Errata Sheet for the U.S. Ponderosa Road / South Shingle Springs Road Interchange Improvements Project Initial Study/Mitigated Negative Declaration

EXHIBIT A to Errata Sheet for the U.S. Highway 50 / Ponderosa Road/South Shingle Springs Road Interchange Improvements Project Initial Study/Mitigated Negative Declaration

Design Standard Decision Document

PONDEROSA INTERCHANGE

**MOTHER LODE DRIVE
TURN LANE CONFIGURATION
SCALE : 1" = 40'**

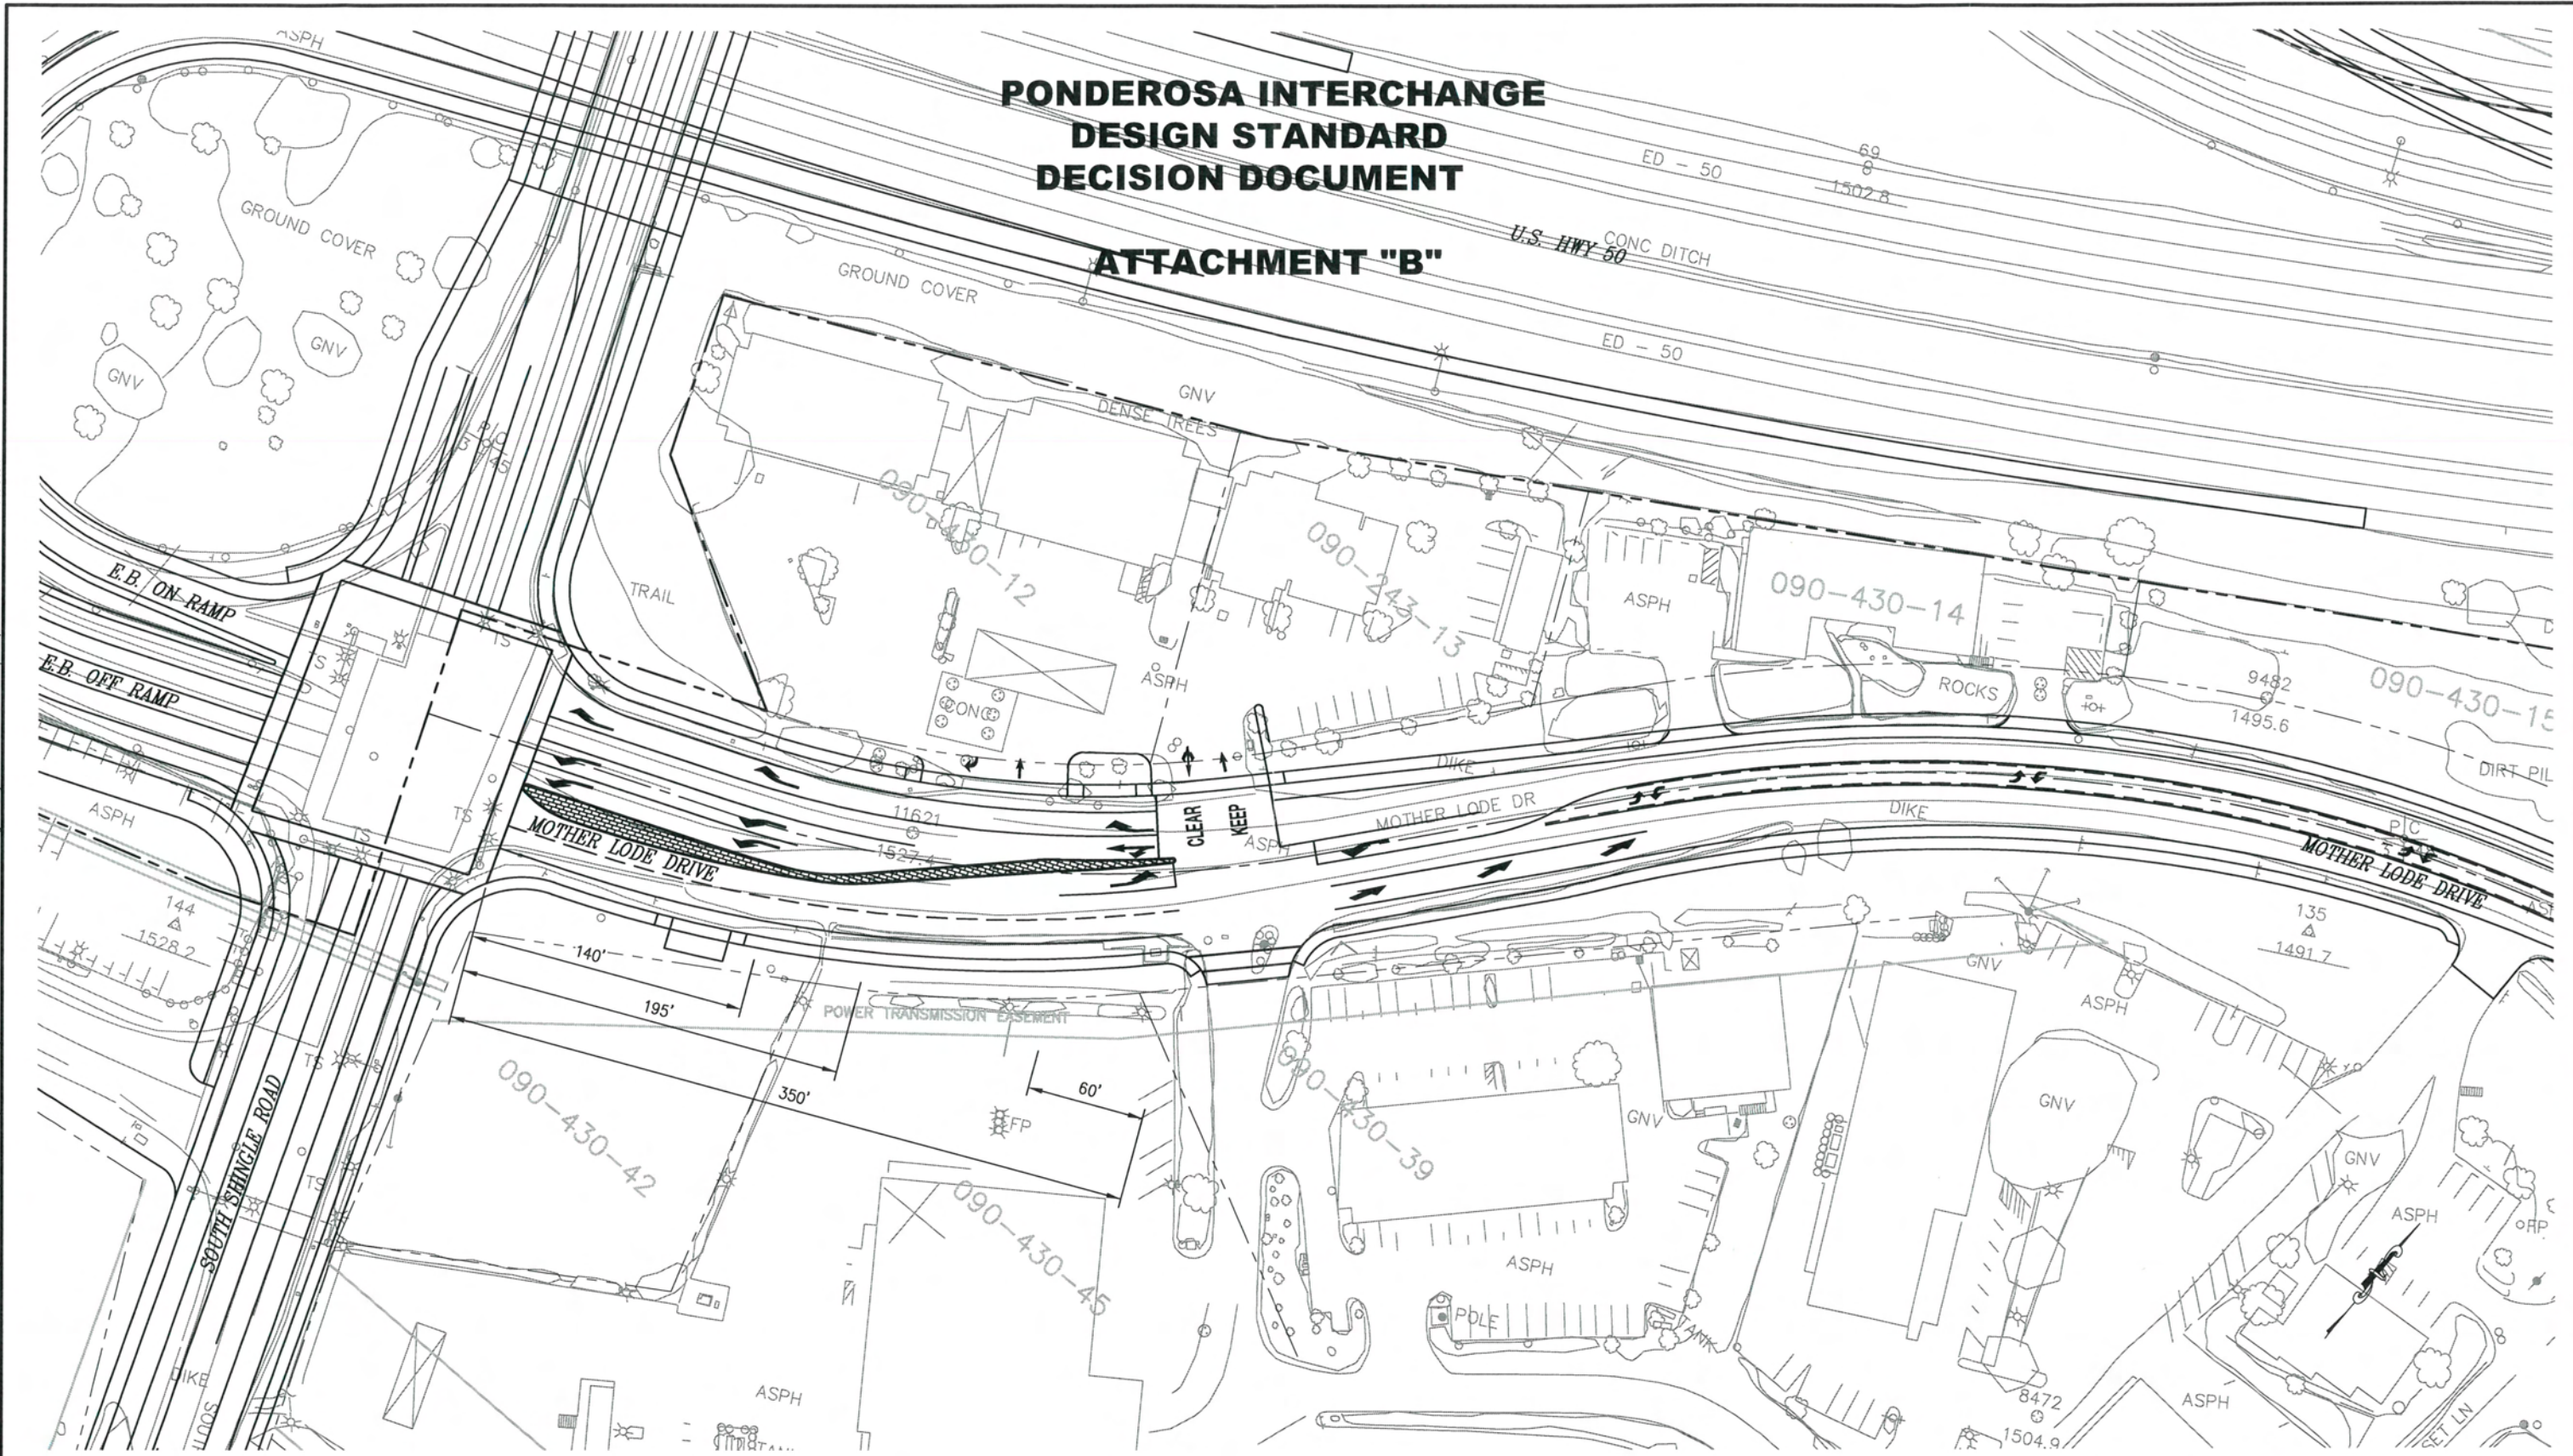
The proposed project proposes to allow full access to APN 090-430-12 and 090-243-13. The intersection would be located 350 feet northeast from the intersection of US-50 Eastbound Off-Ramp / South Shingle Road / Mother Lode Drive along Mother Lode Drive.

The existing driveway along Mother Lode Drive does not meet the current intersection spacing standard referenced. The existing non-standard driveway intersection is approximately 200 feet from the US-50 Eastbound Off-Ramp intersection. There is also a second driveway that is located approximately 350 feet from the Off-Ramp intersection. Both existing driveways currently have no restrictive movements and have full access. The Project is located within a fully developed commercial district which makes compliance with spacing standards more complex and challenging due to the existing conditions. The County has explored several options to make the intersection spacing meet standard, however the resulting impacts to property owners do not justify the improvements.

1. The first driveway that is located approximately 200 feet from the intersection will be restricted to right-in and right-out movements only. A center raised median along Mother Lode Drive will be installed to prevent left turn movements in and out of this driveway.
2. The second driveway that is located approximately 350 feet from the intersection will be the primary access point for the two parcels. Keep clear pavement markings will be used in front of the driveway to help prevent any potential storage que backups from the light at the intersection.
3. A turn pocket has been provided for cars traveling eastbound on Mother Lode Drive looking to turn into the development.

4. Revisions to the PSR GAD's were made to allow for dual left turn lanes for southbound Mother Lode Drive at the intersection. This will increase storage capacity and minimize blocking of the driveway.

Due to the reconfiguration of the Off-Ramp intersection and the widening of Mother Lode Drive as part of the Project, an already difficult access point for the property owners of APN 090-430-12 and 090-430-13 becomes more difficult. In order to accommodate the design standard for 400 feet between intersections, the driveway would have to be relocated. This relocation would require the removal of an Automated Carwash, an Oil and Lube Garage, environmental remediation, reduction in available parking and associated damages and relocation costs for the business. Both of these impact alternatives would require additional right of way and would increase construction costs. The first existing driveway is only 200 feet away from the intersection, whereas the proposed second driveway as the primary access point is 350 feet away. To have 400 feet between intersections would require significant property reconfigurations, building impacts, and right of way costs. Relocation of the driveway will also impact visibility, access and traffic circulation to the Gold Harvest Market & Cleaners, Urban Yogurt, Squeelers BBQ and Subway restaurants. The affected businesses are essential base tenants of the Shingle Springs commercial center. These impacts and additional costs are impractical for a driveway of this nature to conform to the HDM standard. Furthermore, the right of way impacts involved would cause a significant delay to the Project schedule of about 1 year.
